Intel[®] Celeron[®] Processor Specification Update

Release Date: August 2007

Document Number: 243748-051

Figure 1 Celeron® on 0.13 Micron Processor 256K Platforms Workaround

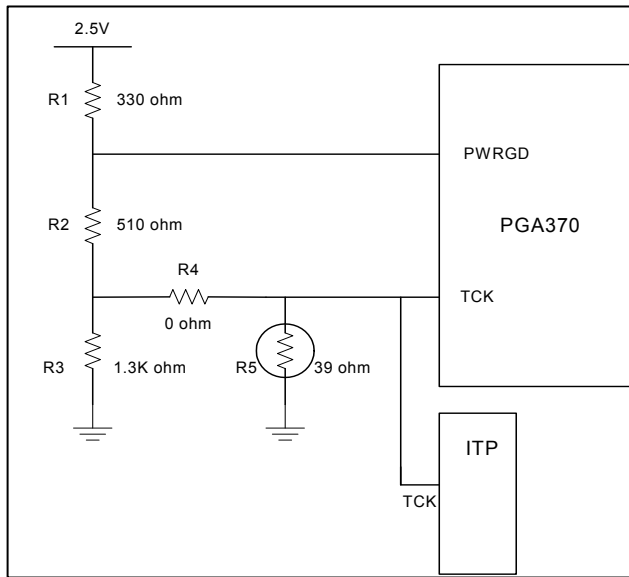
Workaround: To prevent the risk of power-on boot failures or catastrophic thermal failures, a platform workaround is required. The system must provide a rising edge on the TCK signal during the power-on sequence that meets all of the following requirements:

Please note, the example workaround circuits attached require circuit modification for ITP tools to function correctly. These modifications must remove the workaround circuitry from the platform and may cause systems to fail to boot. Review the accompanying notes with each workaround for ITP modification details. If the system fails to boot when using ITP, issuing the ITP 'Reset Target' command on failing systems will reset the system and provide a sufficient rising edge on the TCK pin to ensure proper system boot.

In addition, the example workaround circuits shown do not support production motherboard test methodologies that require the use of the processor JTAG/TAP port. Alternative workaround solutions must be found if such test capability is required.

For Production Boards:
Depopulate R5
